Application No.: 10/751,247

AMENDMENTS TO THE DRAWINGS

Inventor: MASAHIRO YAMANAKA
"TOOL FOR A BICYCLE CRANK AXLE BOLT"
Application No.: 10/751,247
Atty. Docket No. SIC-02-009-3
Page 2 of 9

F1G. 2

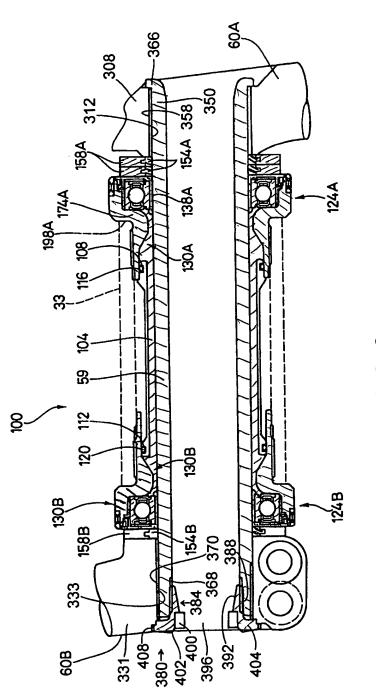
Figs. 2, 4 and 5 have been amended to show proper cross sectional hatching, and Fig. 8 has been amended to eliminate duplicate reference number 478.

Please substitute the enclosed Figs. 2, 4, 5 and 8 for the corresponding Figures filed on December 31, 2003. Figs. 2, 4 and 5 have been amended to add appropriate hatching for the materials therein. Fig. 8 has been amended to eliminate the duplicate reference numbers 478. Annotated sheets showing the changes also accompany the replacement sheets. All sheets are attached to the end of this paper.
